## **Attachment 1**

Letter Number 2.18.079  
EP-PP-01, PNPS Emergency Plan, Revision 49

# PNPS EMERGENCY PLAN

Figure F-1: Initial Notification

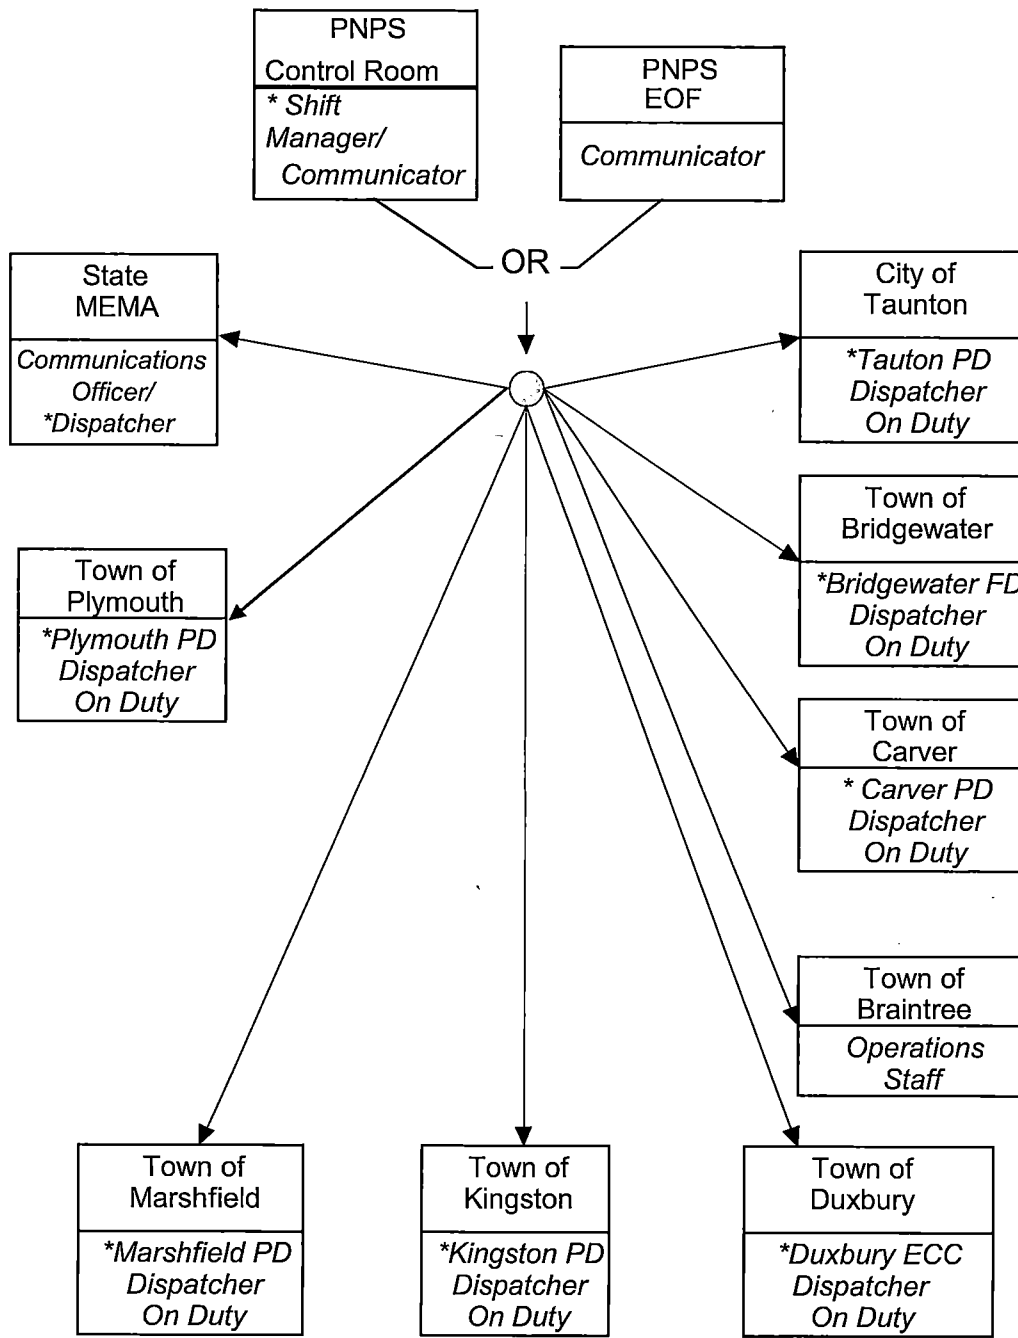
- C. From: "MEMA Region II Communicator" to removal of this reference. Figure F-1, Initial Notification
  - D. From "The MEMA Region II EOC is located at MEMA Region II Headquarters in Bridgewater, Massachusetts. The EOC is located near the plume exposure EPZ and serves...." to The MEMA Region II EOC is located at MEMA Region II Headquarters in Framingham, Massachusetts. The MEMA Region II operation serves as the local liaison with the Commonwealth EOC to coordinate emergency operations among local communities. Section H.3

Figure J-4: Reception Center and Host Schools/Mass Care Shelters, Town of Bridgewater

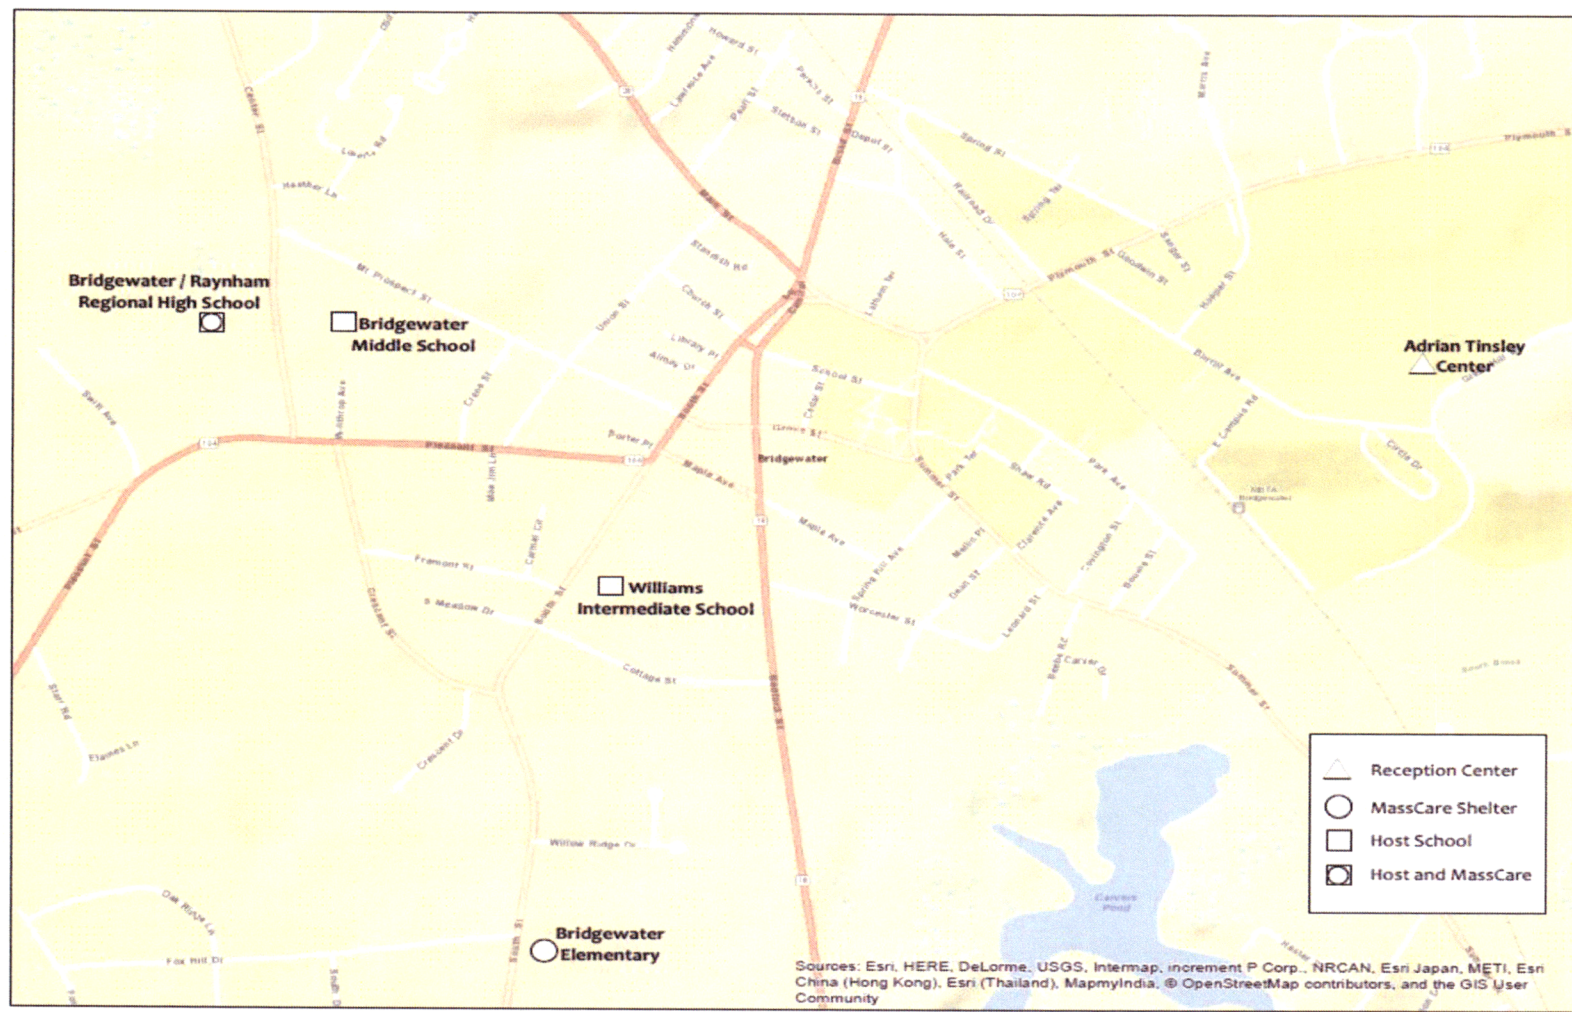
5. Added the "Bridgewater Middle School" to the Reception Center and Host Schools/Mass Care Shelters map, Town of Bridgewater, Figure J-4,
6. Added the acronym SRD (Self Reading Dosimeter) to SID in Section K.2 and K.3. This revision reflects industry and Entergy Fleet standards.

Item 5 in Part I of this form adds the Bridgewater Middle School to the Town of Bridgewater's Reception Center and Host Schools/Mass Care Shelters map, Figure J-4. This change reflects the current availability of host schools within the town. The addition of a host school acts to expand the town's capability to provide host facilities for evacuating school children from the EPZ. This is a change directed by MEMA Region II and agreed to by the local agencies to add another reception center. This change does not change the meaning or the intent of a description, or Pilgrim facilities or equipment, or a process affecting emergency planning function or an element. No further evaluation is required for this change.
